IMPORTANT SAFETY RECALL

This notice applies to your vehicle
Recall Campaign: 17V357 – Swingarm Grommet
Subject: 2015-2017 Slingshot / Slingshot SL / Slingshot SLR
Swingarm Grommet Installation
PLEASE READ IMMEDIATELY

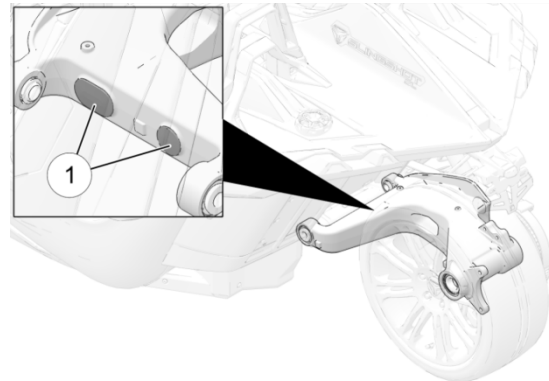
Certain replacement swingarms may have been assembled without grommets ①. Swingarm grommets keep debris and moisture from entering the swingarm casting. Without the swingarm grommets properly installed, contamination of the rear speed sensor may disable the ABS and Traction Control, increasing the risk of a crash.

Your Polaris Slingshot dealer has been authorized to inspect the swingarm and install grommets, if required.
